**CITY OF RAMSEY LAND USE APPLICATION  
TECHNICAL REVIEW FILE**

<b>DATE</b>	OCTOBER 31, 2017	<b>PROJECT ADDRESS</b>	TBD
<b>PROJECT. TITLE</b>	VILLAS AT NORTH FORK (SKETCH PLAN, COMPREHENSIVE PLAN AMENDMENT, ZONING AMENDMENT)		
<b>PROJECT #</b>	17-145		
<b>DEPARTMENT:</b>	Community Development: Planning Division		
<b>TECHNICAL REVIEWER:</b>	Name: Tim Gladhill Phone: 763-433-9826 Email: <a href="mailto:tgldhill@cityoframsey.com">tgldhill@cityoframsey.com</a>

**Sketch Plan, Comprehensive Plan Amendment, and Conditional Zoning Amendment Review**

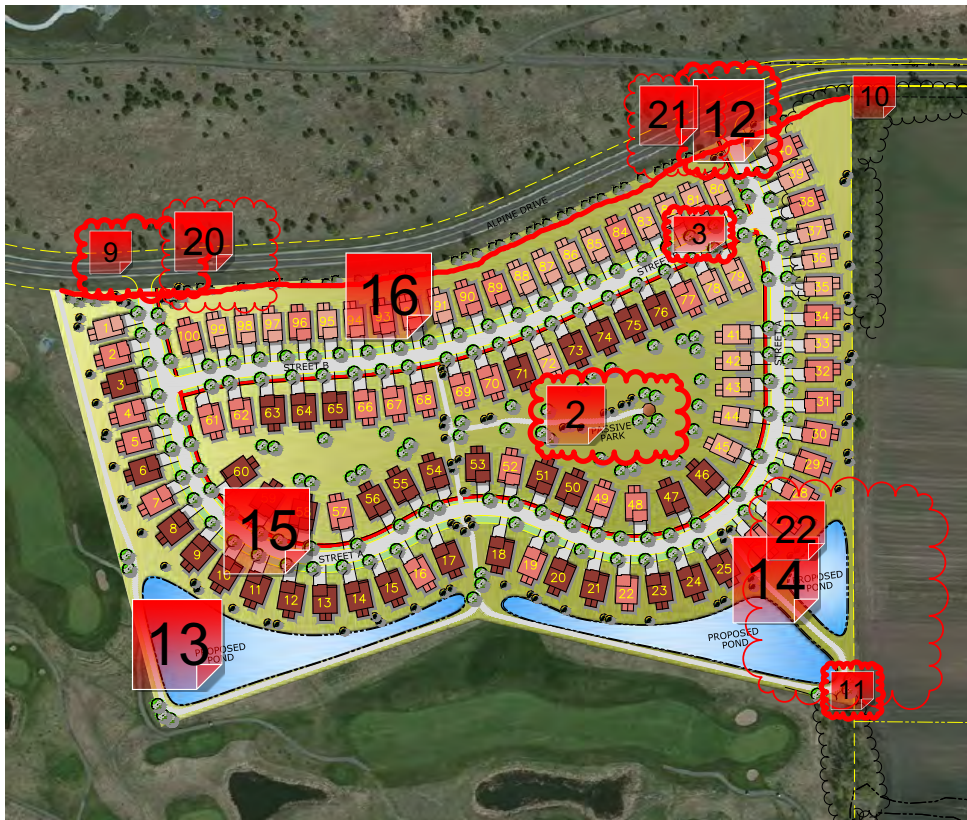
Project will be reviewed based on R-2 Residential District standards as detached townhome units. Proposal shall require a Comprehensive Plan Amendment and Zoning Amendment.

There is no minimum lot size requirement for detached townhomes in the R-2 Residential District.

Minimum driveway length (25 feet) measured from back of sidewalk when present.  
Need lot coverage detail; code specifies max of 35%.

There is no minimum lot width for detached townhomes in the R-2 Residential District.

Please include applicable floor plans. Code specifies a minimum size unit based on number of bedrooms.

Park shall not be eligible for Park Dedication or Trail Development Fee credit.

Include open space calculations. Code specifies 40% general open space, with 10% of which must be identifiable community space.

Street appears to be 29 foot width. Please confirm. Park will need to be restricted to one side of street in this scenario.

Front yard = 25  
Exterior development boundary = 25  
Separation between buildings = 15 (7.5 per unit)

Please provide net density calculations. Include rights of way. Exclude wetlands.

Include acreage calculations:  
Gross acreage  
Wetland acreage  
Net acreage

Include full legal description.

Include name and address of owner in addition to subdivider.

Include boundary survey.

Add pedestrian crossing detail.

Pavement markings.  
Pedestrian accuated signals.

City needs to determine if trail is to be constructed here.

Trail connection to Pearson Park?

Concerned with vision clearance triangle in this location. It is assumed that internal roadways will be public.

Need to review stormwater. Reminder that first 1" of rainfall must be infiltrated on site.

It is assumed that the internal trails will be private. The sidewalks along public roads will be public. Sidewalks will be required on one side of each public road.

No Parking on one side of street. Must post No Parking Signs.

Must share architectural renderings.

Eave overhangs should not be in easements. If this doesn't work, please discuss with City.

The western entrance must align with the existing street on the north side of Alpine Drive.

A traffic study will be required for this plat. The Study must also look at the visibility from the east intersection.

An easement will be required for connecting to Municipal Sewer and Water. This will require removing lots.
